## Bowie #2 inspection report

### PERMIT INFORMATION

<b>Permit Number:</b> C-1996-083 <b>Mine Name:</b> Bowie No. 2 Mine <b>Operator:</b> Bowie Resources, LLC <b>Operator Address:</b> Mr. Art Etter P.O. Box 1488 Paonia, CO 81428	<b>County:</b> Delta <b>Operation Type:</b> Underground <b>Permit Status:</b> Active <b>Ownership:</b> Private
	<b>Operator Representative Present:</b>  Ryan Wilson, Art Etter
<b>Operator Representative Signature: (Field Issuance Only)</b>

### Locations of Gob Pile Areas Related to the SL-04 Application

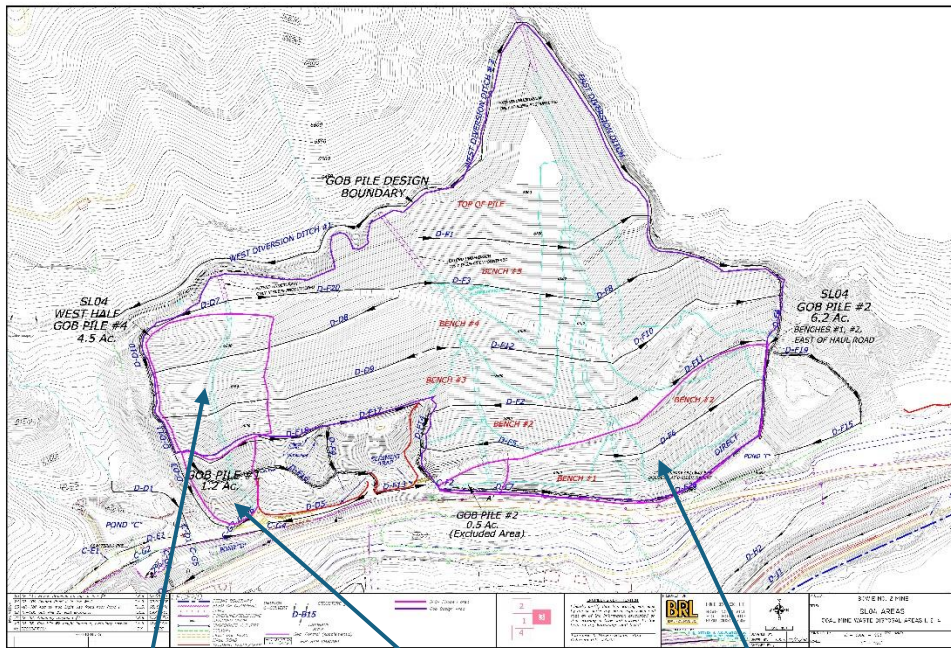
All the specifications were met with the following exception. In the specifications, Ditch F-7 (below Gob Pile #2) is listed as a riprap-lined channel. However, field observation revealed that it is not riprap lined. BRL has submitted a Minor Revision to change the analysis and specifications for this ditch; this revision (MR-211, submitted June 30, 2025) must be approved before the Division can release any tasks related to Gob Pile #2.

Another issue is with Ditch F-4. Part of it will need to be repaired where there is a crossing for trucks hauling soil to Gob Pile #2. BRL should make this repair and provide the Division with proof of the work, such as photographs.
